Final
**Remedial Investigation/Feasibility Study
Work Plan**

for
AOC I and AOC R

at the
**Former U.S. Naval Ammunition Support Detachment (NASD)
Vieques Island, Puerto Rico**

August 2004

Figure 2-9
AOC R Surface Soil Detections Above Screening Criteria and Background
Former NASD, Vieques, Puerto Rico

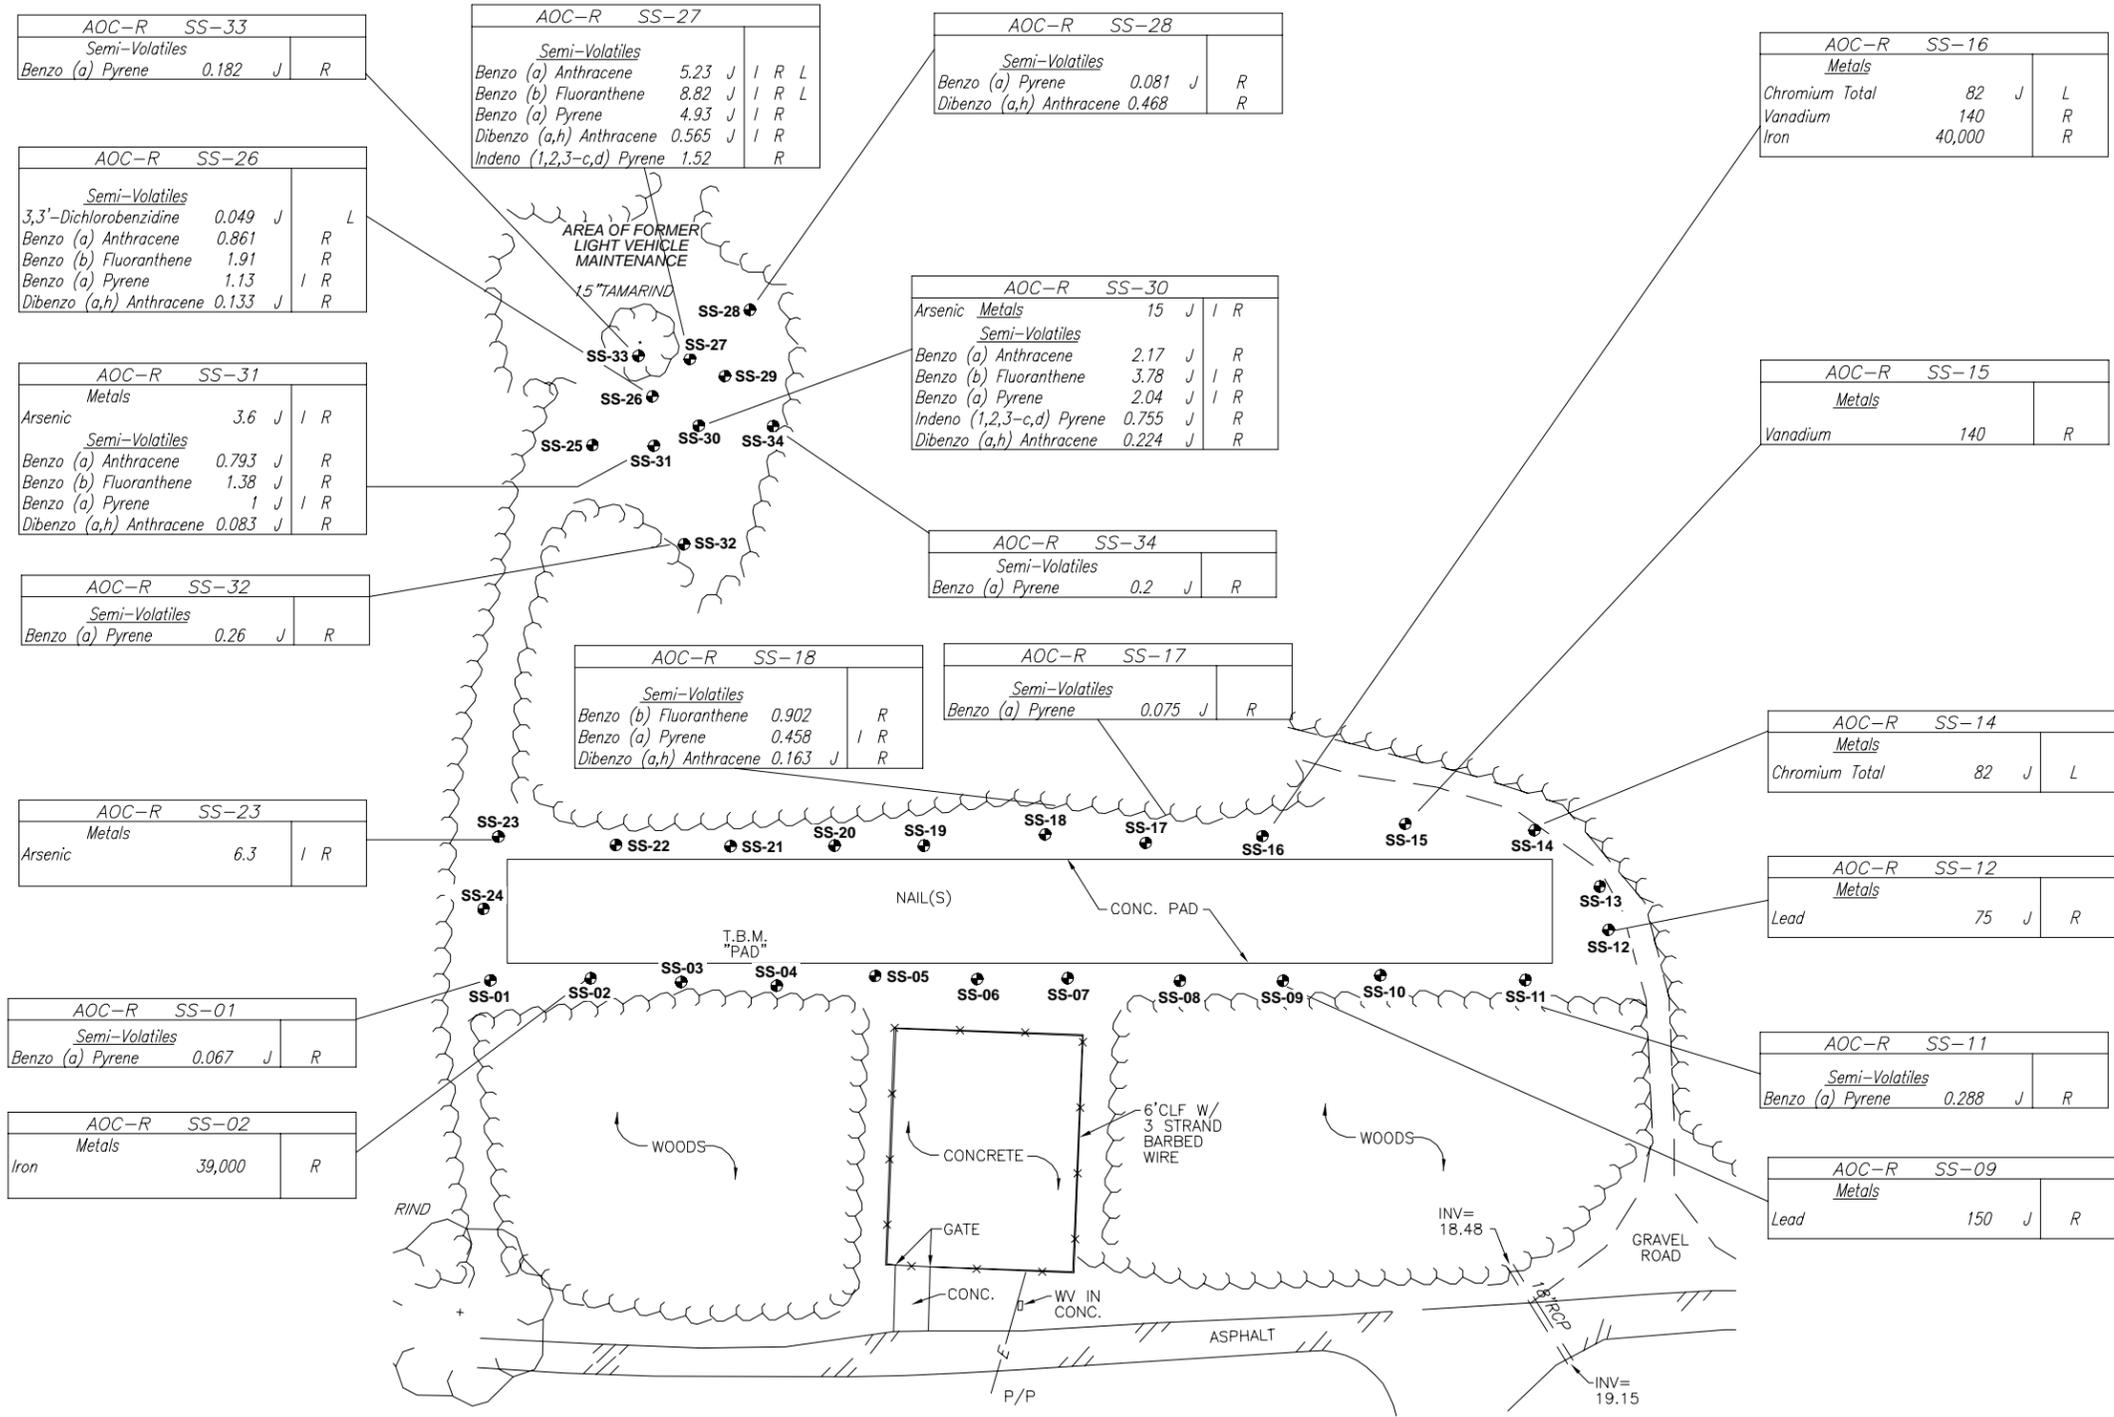
Figure 2-3 – The orientation of the site presented in this figure does not correlate with Figure 1-4. Aligning the north arrows of each figure results in two different orientations of the concrete pad (southwest to northeast in Figure 1-4, and northwest to southeast in Figure 2-3). The correct orientation must be determined and the figure(s) adjusted as necessary.

Figure 2-3 (now Figure 2-9) has been corrected and the north arrow has been moved to the correct orientation.

Figure 3-1
Conceptual Site Model for AOC I: Asphalt Site
Former NASD, Vieques, Puerto Rico

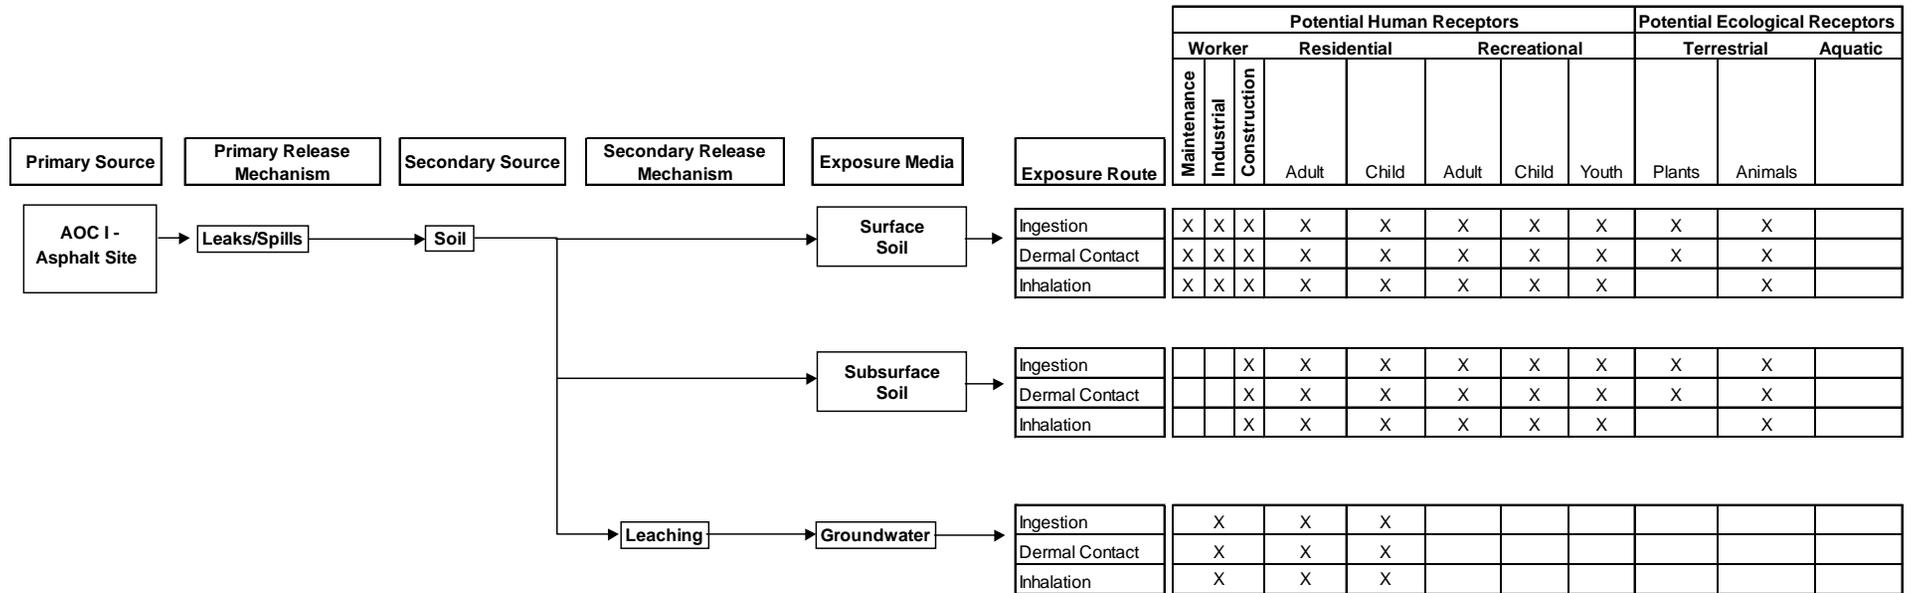
Figures 3-1 and 3-2 - The conceptual site models should show all receptors and exposure pathways considered and should include the rationale for eliminating receptors and exposure pathways from consideration for each site as required by US Environmental Protection Agency (EPA) Risk Assessment Guidance for Superfund (RAGS) Part D guidance (which is listed in Section 5.2 as a reference for conducting the human health risk assessment).

A topographic map has been included in Section 2 of the revised work plan. The text will be revised to indicate that the topography is relatively flat and that surface runoff is not a key migration pathway of concern. Appropriate changes to Figure 3-1 have been made.

Figure 3-2
Conceptual Site Model for AOC R: Former Construction Staging Area and AST
Former NASD, Vieques, Puerto Rico

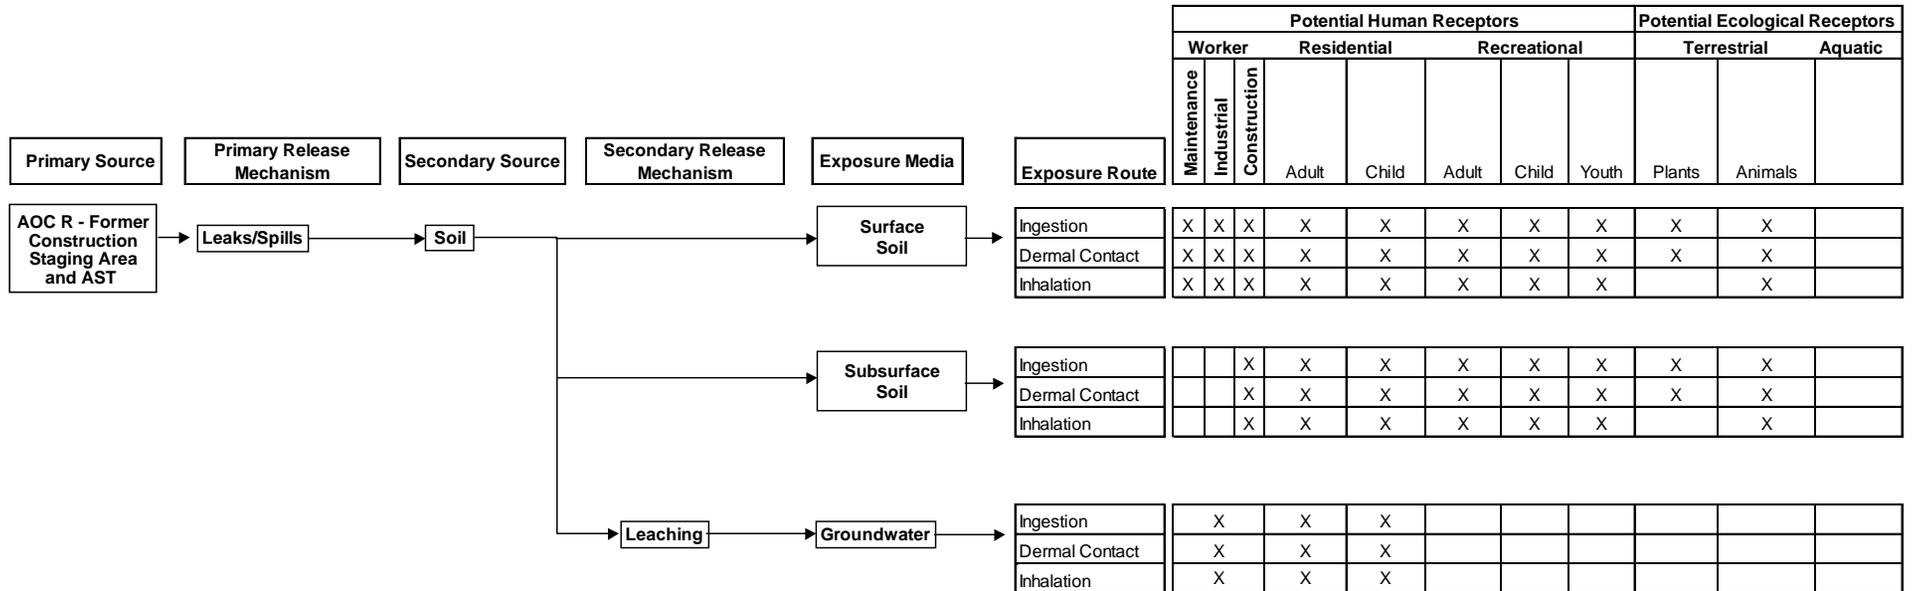
Figure 3-2: Please clarify why recreational exposure to surface water and sediment is not evaluated.

A topographic map has been included in Section 2 of the revised work plan. The text will be revised to indicate that the topography is relatively flat and that surface runoff is not a key migration pathway of concern. Appropriate changes to Figure 3-2 have been made.

Figure 4-1
AOC I Proposed Monitoring Well Sample Locations
Former NASD, Vieques, Puerto Rico

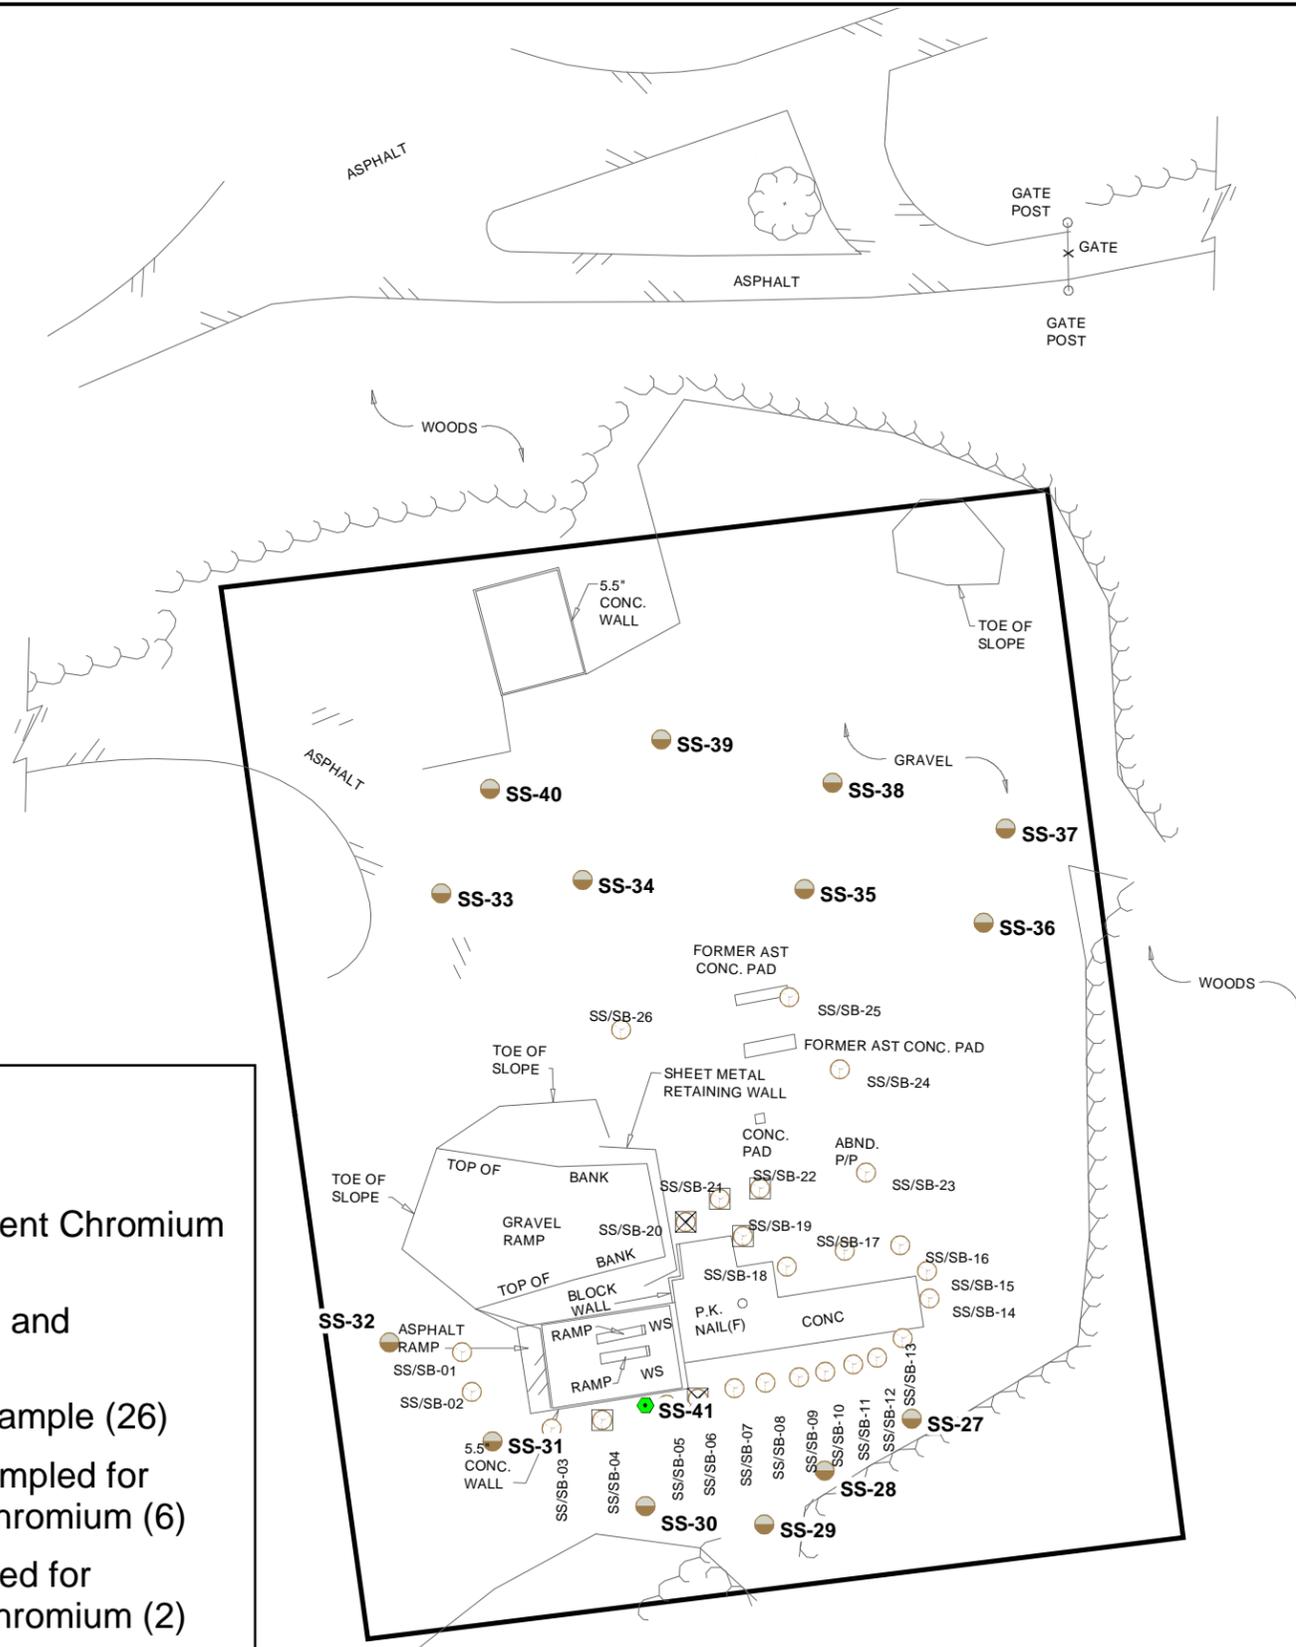
Monitoring well locations, Figure 4-1: Well locations need to be re-evaluated in the context of a better description of site activities and a more detailed figure, as noted in a comment above. Based on the present information, the following is noted: a) Wells MW-02, MW-03 and MW-04 are all located on what is presumed to be the up gradient side of the process area. Placing one well here, targeting the area of maximum known TPH concentrations is appropriate. But it is more efficacious to place other wells just to the north of where site activities took place - or directly in the process area where possible. If groundwater contamination is present, it is more likely to be detected just down gradient of the entire possible source zone. Although any new information on site history may effect final locations, the EQB recommendations on amending

Figure 4-1 – Identify/illustrate the following on this figure:

Figure 4-1– First, the site should be reviewed for operational history to determine the most likely location for contaminants to be released and wells should be placed at these locations. In the event that no operational data is available, then we suggest moving Monitoring wells MW-2 and MW-4 should be relocated. MW-2 should be placed 10-20 feet north of the ramps, MW-4 should be placed 10-20 feet northwest of SB-25 (presumed downgradient of the ASTs and centered on the ASTs). The previously planned locations were more indicative of background than release area impacts. The new suggested locations should detect operations impacts. Note that if cracks in the concrete, surface staining, collection sumps or other indications of impacts are located in the operations area then the wells should be moved to center them directly downgradient of these area as close to the observed impact area as possible.

Figure 4-1 has been revised to relocate the monitoring wells.
